**Lee Nuclear Station Response to Request for Additional Information (RAI)**

**RAI Letter Dated: June 22, 2010**

**Reference NRC RAI Number: ER RAI 139, Cultural Resources**

Revised Figure 4.1-2

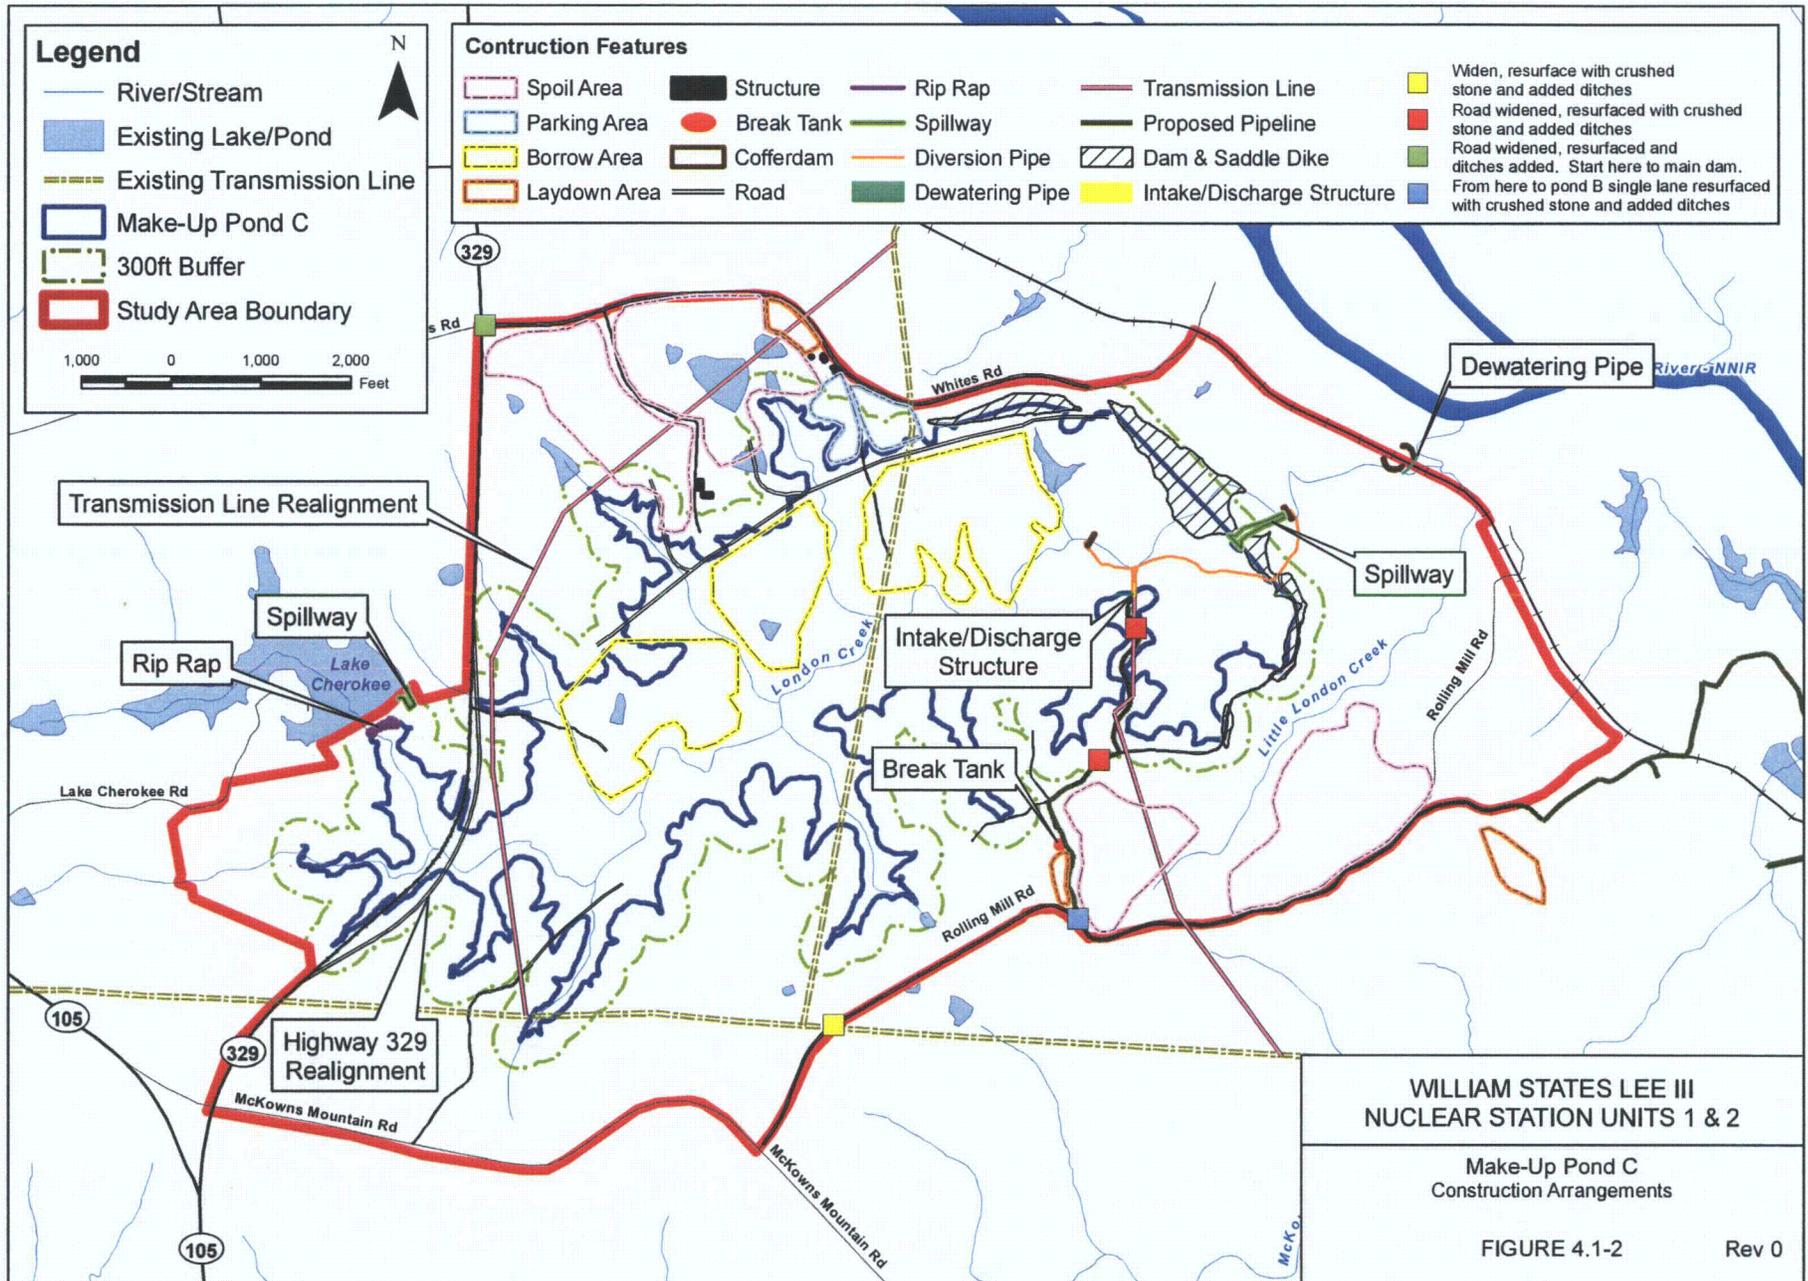
Provide information regarding the location of the proposed new transmission line, its length, corridor width, cover/habitat types it intersects, etc. Provide a graphic depiction of the location of the new transmission line corridor.

The new 44-kV transmission line begins at the intake/discharge structure for Make-Up Pond C and connects to the existing 44-kV line within the Lee Nuclear Site (see attached revised Figure 4.1-2, Attachment 157-02). This transmission line corridor is approximately 5,700 feet long and is 100 feet wide. Land cover types within the transmission corridor are provided within revised Table 4.3-2. Associated revisions to the text in the ER Supplement are provided in Attachment 157-05.

Attachment 157-03  
Revised Figure 4.3-3

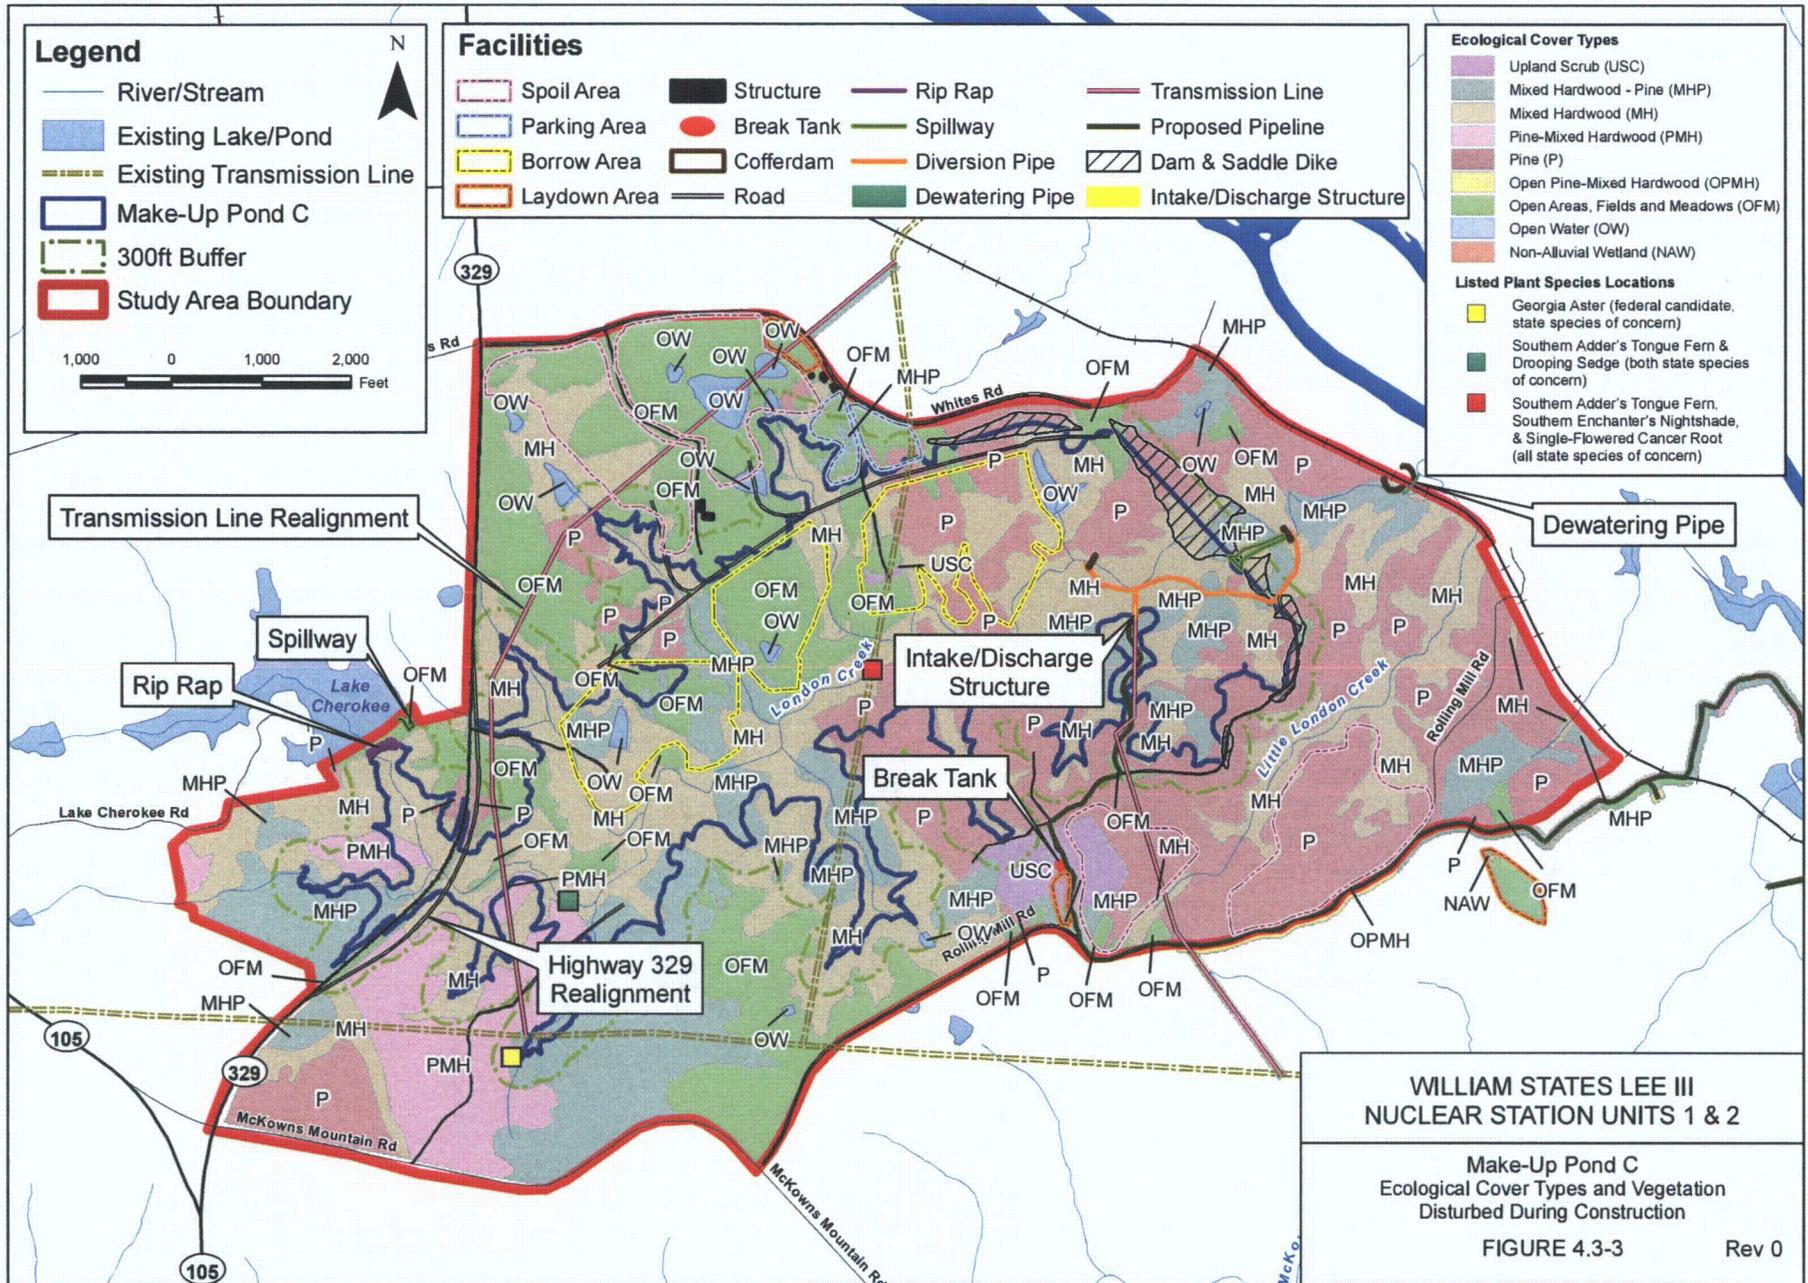
Provide clarification on whether the lay-down area in OFM habitat outside the Pond C study area is accounted for in Table 4.3-2. If not, provide a revision of Table 4.3-2 that accounts for this lay-down area.

Provide clarification on whether the habitat impacts quantified in Table 4.3-2 of the Supplement to the ER for the re-routing of the 44-kV transmission line include the part of the re-routed transmission line that occurs outside the Pond C study area. Distinguish between such impacts inside and outside the Pond C study area both in the text in Section 4.3.1.2.2 and in a revision of Table 4.3-2.

Figure 4.3-3 of the ER Supplement has been revised (Attachment 157-03) to show impacts to cover types included in the revised Table 4.3-2. The raw water pipeline within the Lee Nuclear Site extends outside of the figure, however, it is depicted on Figure 4.3-1 in the ER Supplement. This figure has not been revised, but is included as an attachment for reference (Attachment 157-04). As clarification wetlands were mapped as a separate cover type within the Lee Nuclear Site but not within the Make-Up Pond C study area. The jurisdictional status and extent of wetlands shown on Figure 4.3-1 are subject to verification by the U.S. Army Corps of Engineers. An updated discussion concerning wetland impacts from Make-Up Pond C construction features located outside Make-Up Pond C is provided in response to RAI 164.
